ADDENDUM NO. FIVE

**HOFFMAN WAY DRAINAGE IMPROVEMENTS
88TH AVENUE TO 90TH AVENUE**

PROJECT NO. 19-244

CITY OF THORNTON, CO

HOFFMAN WAY DRAINAGE IMPROVEMENTS DEMOLITION PLAN	
Designer:	R. BYRNE
Detailer:	E. BEDNAR
Sheet Subset:	--- Subset Sheet:

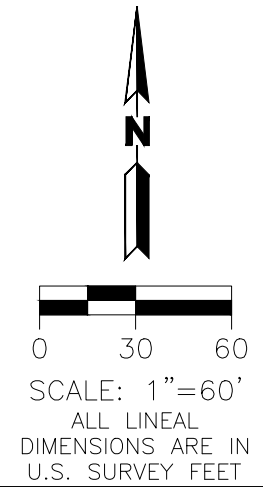
Question 5: “Is there Sanitary Sewer pipe removal?”

Answer 5: The existing sanitary sewer drop manhole will need to be removed. Existing sanitary sewer pipe is to be abandoned in place. An additional manhole removal under item 202 of the bid tab sheet has been added and a revision to sheet 12 has been issued to clarify the manhole removal/replacement.

STANDARD STRUCTURE EXCAVATION AND STRUCTURE BACKFILL DETAILS

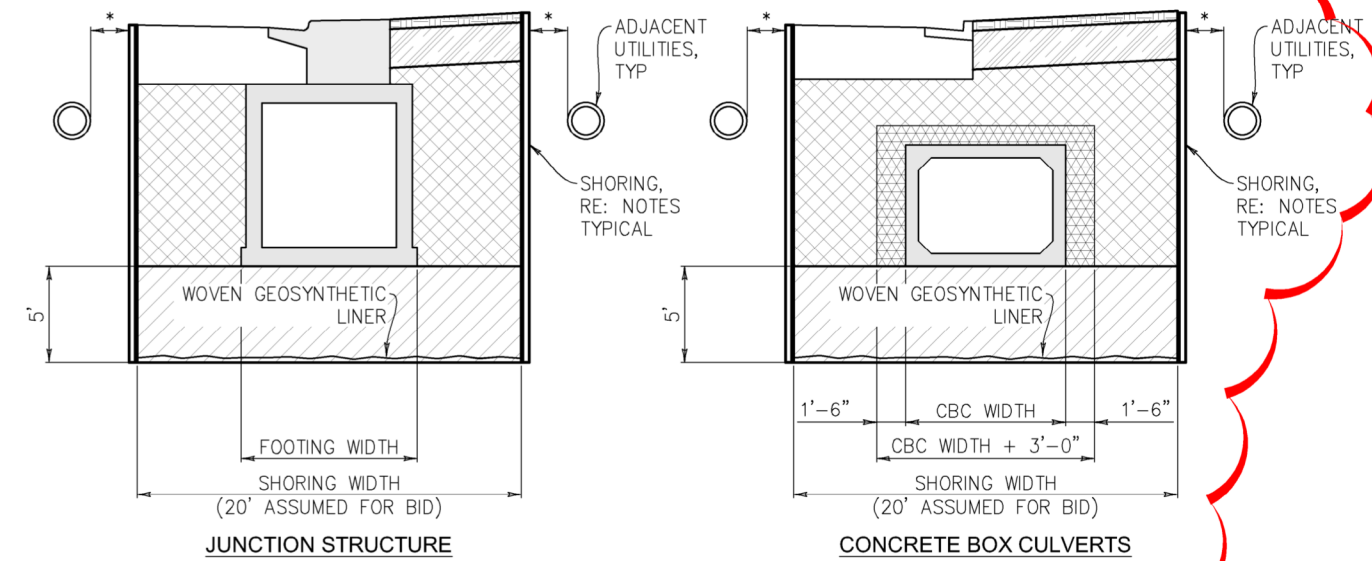
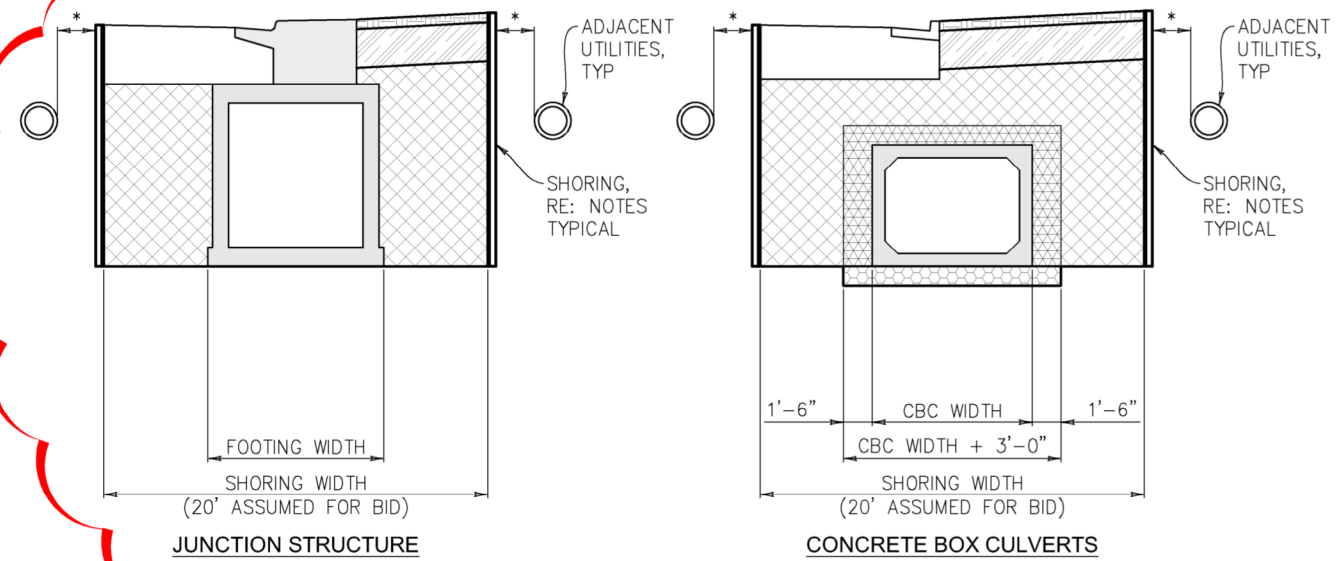
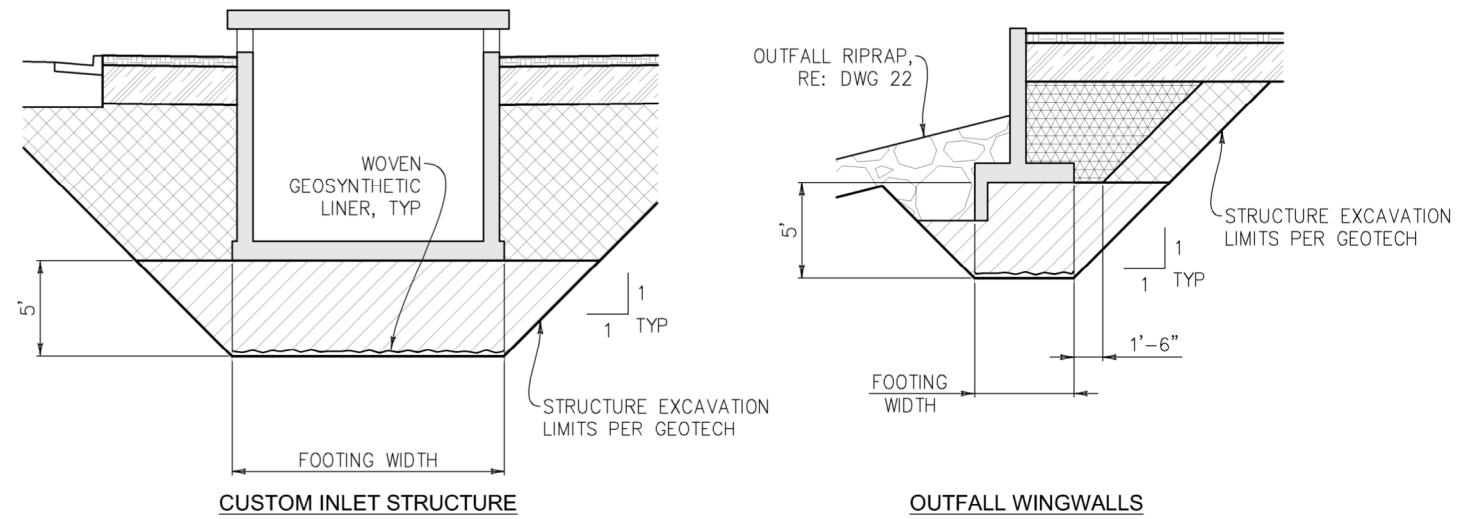
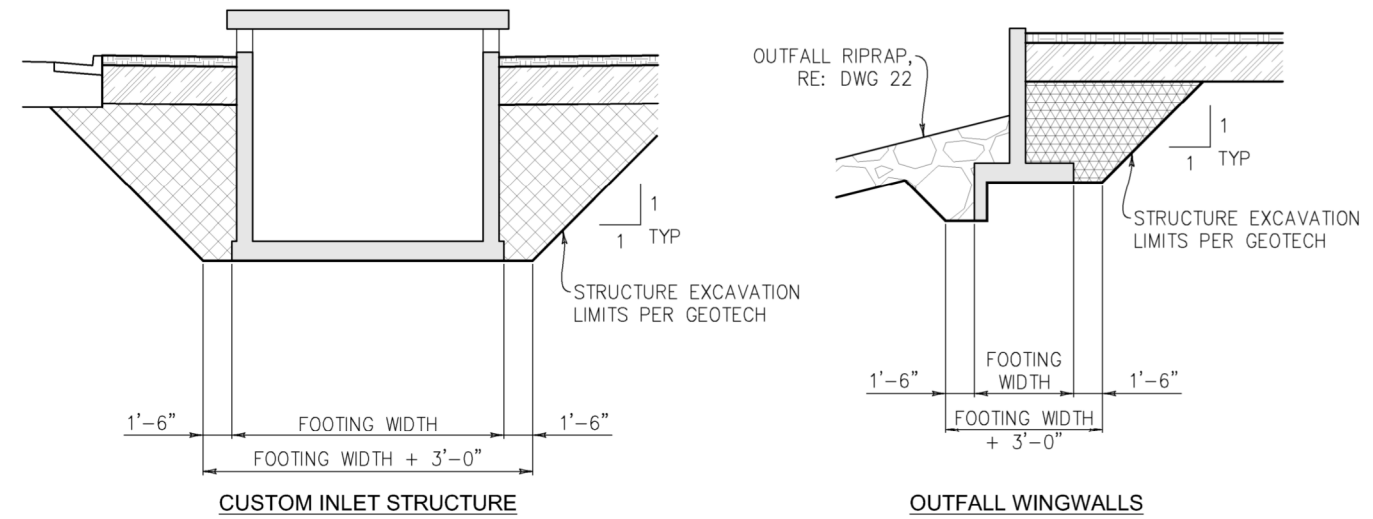
Question 1: "Sheet 55 shows two types of structure excavation; one for standard and one for special. There is significant cost associated with shoring and dewatering depending on which detail will be used. Given the recommendation of the soils report, it appears the special details will be used for the entire length of the project. Is this assumption correct? If not, how will it be determined when the standard or special details are needed?"

Question 2: "The Geotech report notes the soil will likely be classified as a type C soil, which has a 1-1/2:1 slope ratio for unshored excavations. The details on sheet 55 show a 1:1 slope ratio. Were the quantities determined factoring a type C soil or the 1:1 slope ratio

Answer 1: From general notes (No. 3) on sheet 54 of the construction documents, a representative of the geotechnical engineer shall observe the excavation and determine the need to utilize the special structure excavation requirements. Sheets 55 and 56 of the construction documents have been revised to reflect bid quantity assumptions based on the requirement to protect adjacent utilities via trench box or temporary shoring. With water table elevations varying across the site, it was assumed that 50% of the trench excavation would require special structure excavation and backfill, based on an average design groundwater level of seven feet below existing grade, as determined by the project geotechnical engineer. For bidding purposes, the contractor should use the standard structure excavation and backfill details. The additional over-excavation and backfill that may be required to achieve an increased allowable bearing pressure of 1,500 psf has been approximated in bid items 18, 19, and 36. See notes on revised sheets 6, 55, and 56.

Answer 2: Quantities provided in the bid tab used the following assumptions for structural excavation and backfill.

The details shown on Sheet 55 are standard details. However, due to site constraints, including but not limited to, utility interference, and pavement/concrete/turf restoration, the quantities assume the use of a trench box or temporary shoring for structure excavation estimates, where layback slopes are not achievable.
